<b>DART AEROSPACE LTD</b>	<b>Work Order:</b>	76827
<b>Description:</b> Crosstube Assembly (205/212 Low Aft)	<b>Part Number:</b>	D212-664-247
<b>Inspection Dwg:</b> D212-664-247 Rev: B		Page 1 of 1

B	REVISE GENERAL NOTES/PART LIST; UPDATE TO CURRENT STANDARDS: ADD -247B (ZN C4-2, D5-2)	RF	09.09.30
A	NEW ISSUE	CP	07.07.07
REV.	DESCRIPTION	BY	DATE
DESIGN	RF	DART AEROSPACE LTD HAWKESBURY, ONTARIO, CANADA	
DRAWN	RF		
CHECKED	RF	DRAWING NO.	REV. B
MFG. APPR.	RF	D212-664-247	SHEET 1 OF 4
APPROVED	RF	TITLE	SCALE
DE APPR.	RF	CROSSTUBE (205/212 LOW AFT)	NTS
DATE	09.09.30	COPYRIGHT © 2007 BY DART AEROSPACE LTD THIS DOCUMENT IS PRIVATE AND CONFIDENTIAL AND IS SUPPLIED ON THE EXPRESS CONDITION THAT IT IS NOT TO BE USED FOR ANY PURPOSE OR COPIED OR COMMUNICATED TO ANY OTHER PERSON WITHOUT WRITTEN PERMISSION FROM DART AEROSPACE LTD

DRAWING NO. D212-664-247	TITLE CROSSTUBE ASS'Y (205 LOW AFT)	REV. B	<b>DART AEROSPACE LTD ENGINEERING ORDER</b>		D.E.O. NO. D212-664-247-B-1	SHEET NO. SHEET 1 OF 1	SCALE NTS
DRAWN <i>q</i>	CHECKED <i>ASS</i>	MFG. APPR. <i>AB</i>	APPROVED <i>MD</i>		DE APPR. <i>MD</i>		
DATE 11.07.15	DATE 11.07.20	DATE 11.07.21	DATE 11/07/21		DATE 11.07.21

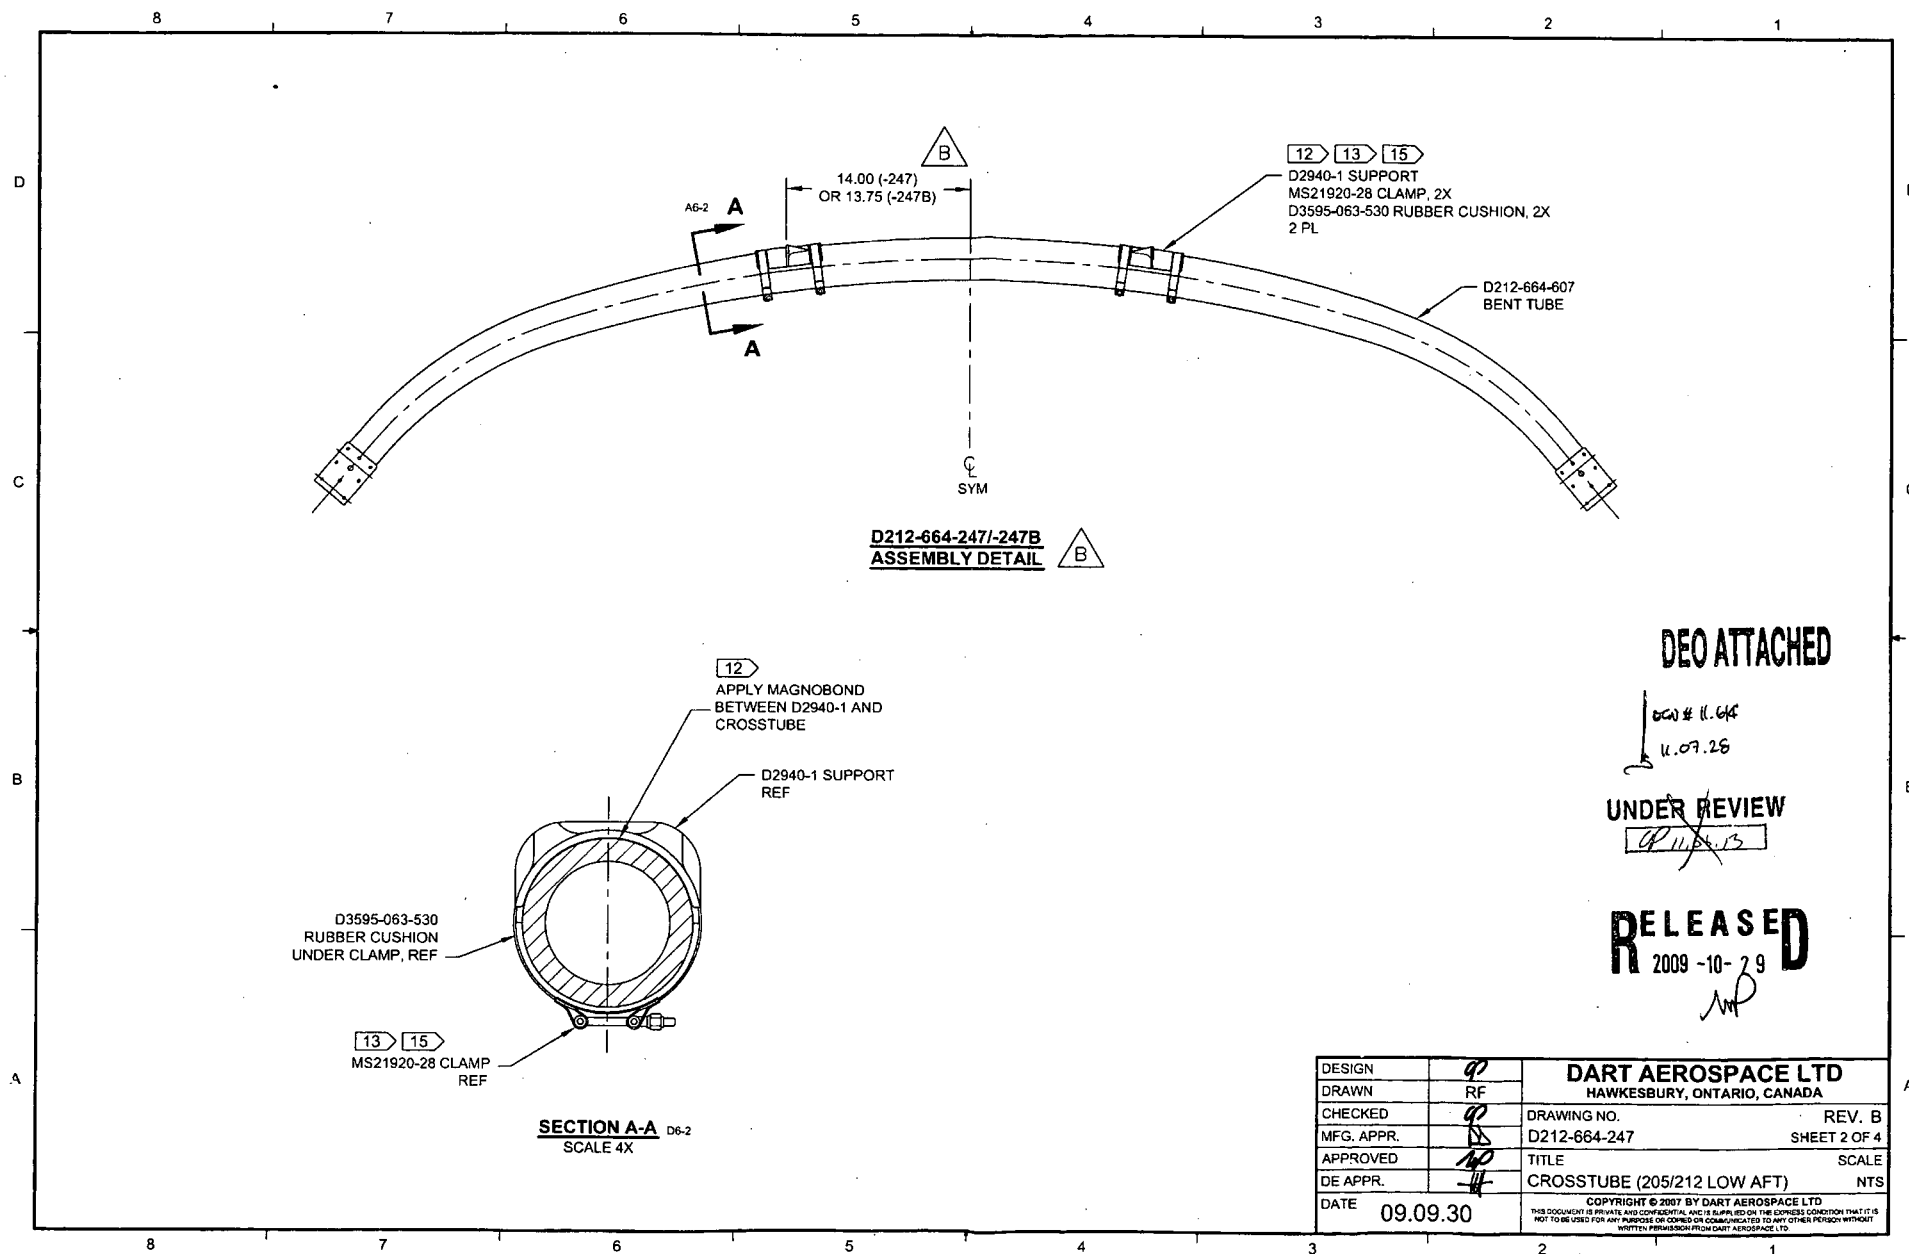
**PURPOSE:**

REPLACE MAGNOBOND WITH PROSEAL.

**CHANGE:**

NOTE 12 & 15, SHEET 1 IS AMENDED AS FOLLOWS:

IS:

Item	Qty -247	Qty -247B	Part Number	Description
9	A/R	A/R	PROSEAL 890 B-2	SEALANT, AMS-S-8802 CLASS B-2

IS:

12) TO INSTALL D2940-1 SUPPORT: ABRASE MATING SURFACE OF SUPPORT AND CROSSTUBE WITH 180-GRIT SANDPAPER AND REMOVE RESIDUE WITH MEK (OR EQUIVALENT). APPLY A 0.04" TO 0.07" THICK LAYER OF PROSEAL 890 CLASS B-2 (OR AMS-S-8802 CLASS B-2) SEALANT TO MATING SURFACE OF SUPPORT.

15) TORQUE CLAMPS 80 TO 100 IN-LB. ENSURE AT LEAST 1.5 THREADS SHOWING IN SAFETY AND THAT NUT HAS NOT BOTTOMED-OUT AFTER TORQUING. **PRIOR TO PACKAGING, RE-CHECK TORQUE ON CLAMPS AFTER PROSEAL 890 SEALANT HAS CURED FOR 72 HOURS.**
